**PEQUEA VALLEY
SCHOOL DISTRICT
BOARD MEETING**

D.A.O. AND TURF FIELD DESIGN

LIGHTNING PROTECTION
CODE COMMENTS – RAMP
REQUIREMENT
BOARD ROOM LETTERING

RAMP REQUIREMENT -

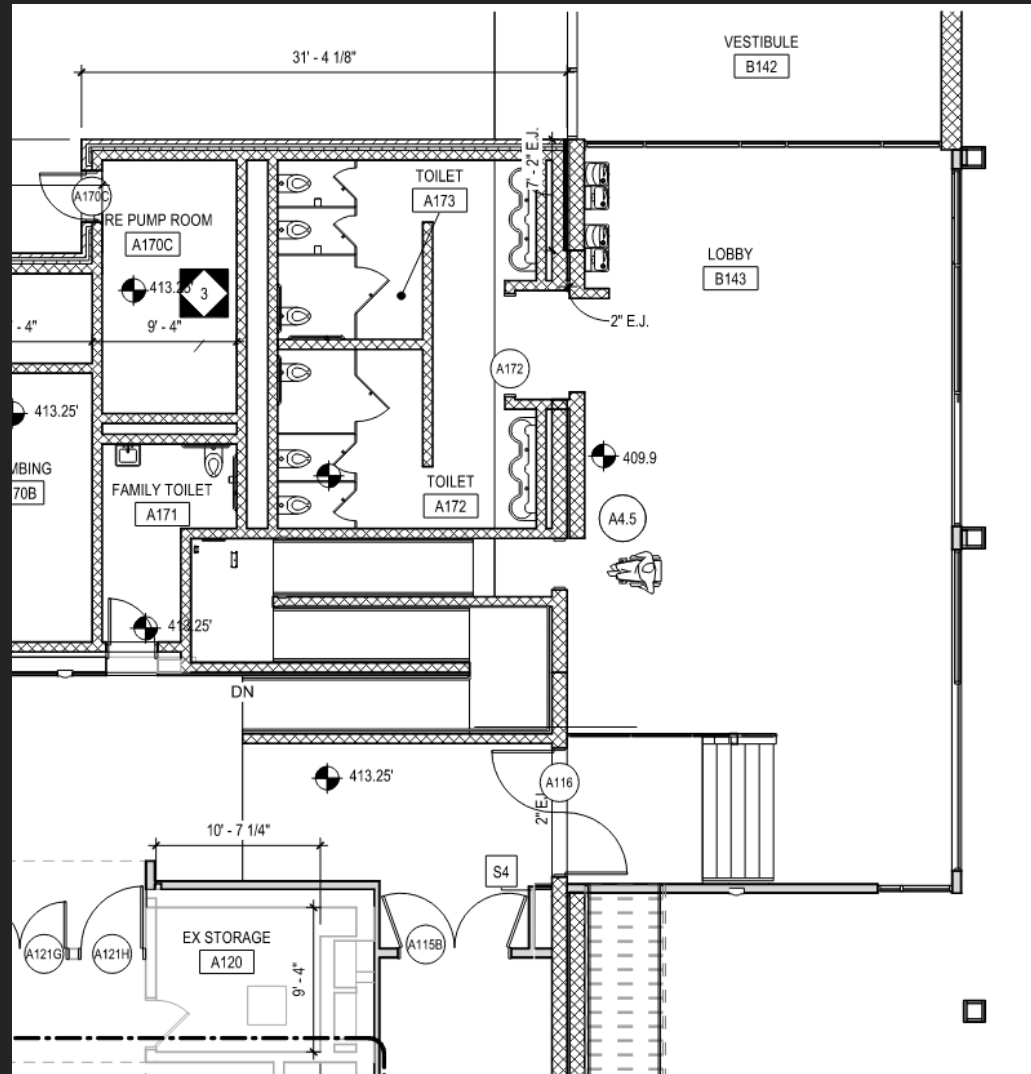
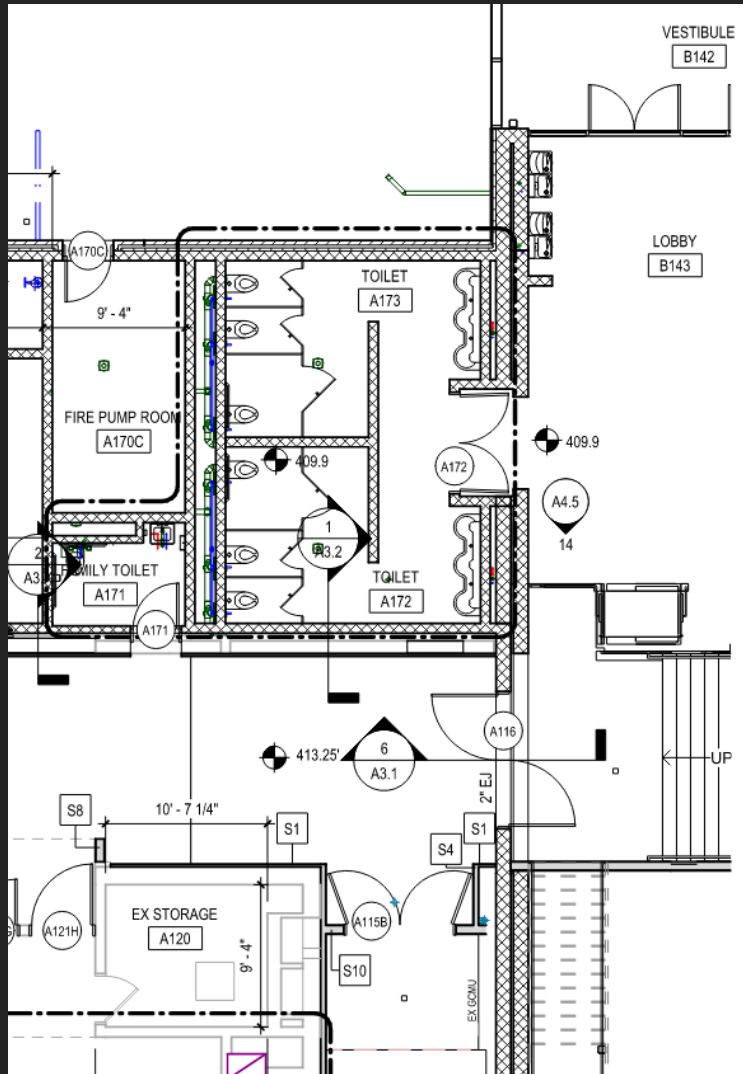
The use of a wheelchair lift in the renovation project is prohibited due to the overlap of new construction and existing spaces. The existing site constraints to not make the use of a ramp a reasonable hardship for an exception.

OPTION 1:

REMOVE WHEELCHAIR LIFT. MODIFY CONCRETE SLAB ON DECK AND STEEL PAN STAIRS. PROVIDE CONCRETE WHEELCHAIR RAMP WITH FOUNDATIONS, LANDINGS, MESH GUARDRAIL SYSTEM, AND RUBBER FLOORING.

OPTION 2

REMOVE WHEELCHAIR LIFT. MODIFY CONCRETE SLAB ON DECK AND STEEL PAN STAIRS. EXTEND BUILDING PLAN NORTH TO PROVIDE ROOM FOR RAMP. PROVIDER CONCRETE WHEELCHAIR RAMP WITH FOUNDATIONS, CMU WALLS, LANDINGS, AND RUBBER FLOORING.

OPTION 3

REMOVE WHEELCHAIR LIFT. MODIFY CONCRETE SLAB ON DECK. PROVIDE ELEVATOR WITH 3 STOPS TO MATCH ELEVATOR AT DAO.
